**CITY OF NAPOLEON
BUILDING CONSTRUCTION PERMIT
(1, 2 or 3 Family Dwelling)**

Permit No. 202-75

Street No. 625 Buckeye Lane

Zoning "R" Intended use of Building: NEW ONE FAMILY DWELLING.

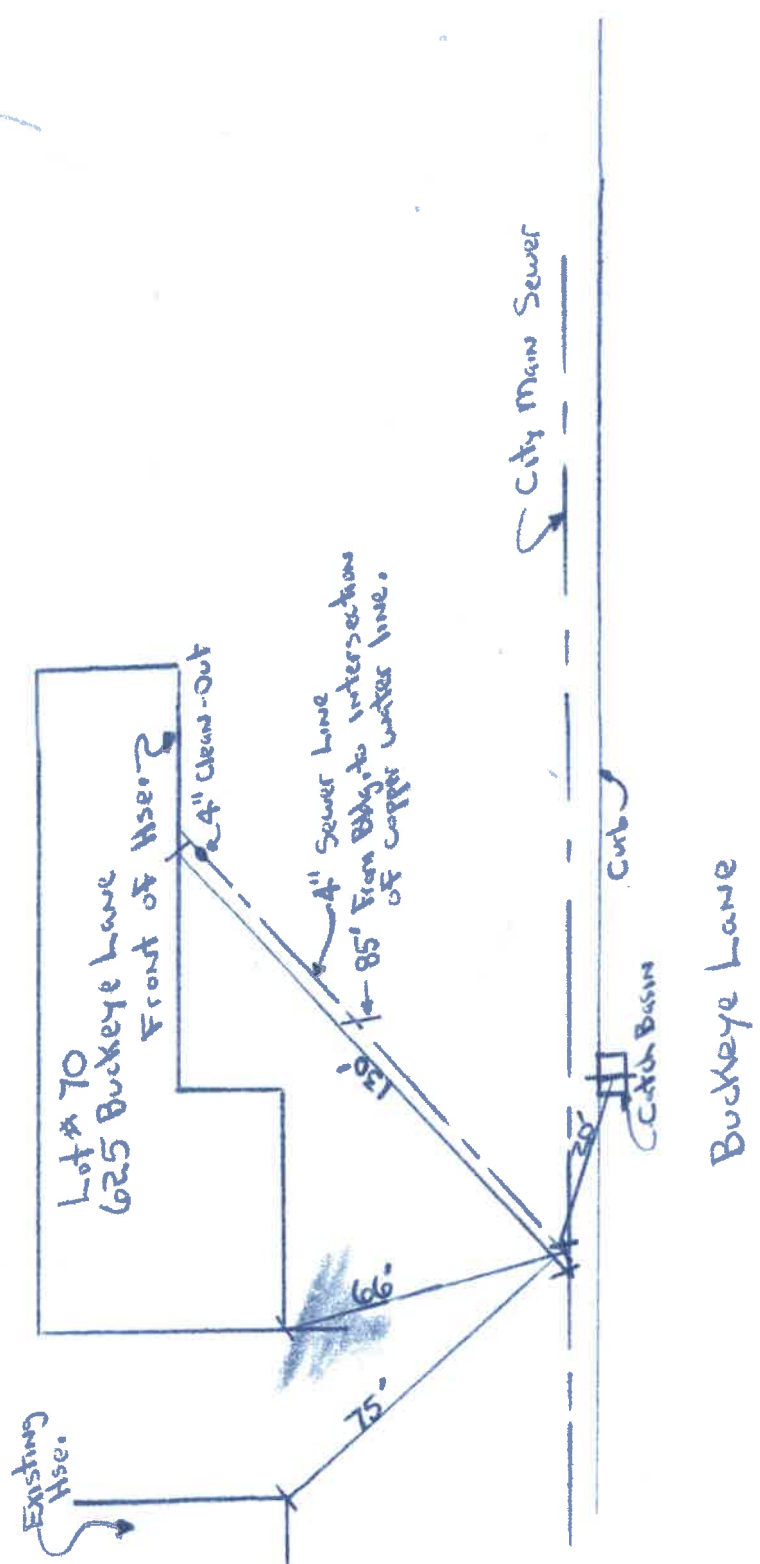
Conducted 5 psi. air test.

5 psi. air test inspected and approved by *FW/T 4/18/75*

4" Vt. Clay
4-18-75
Front of hse.
@ Tap 8'-4"
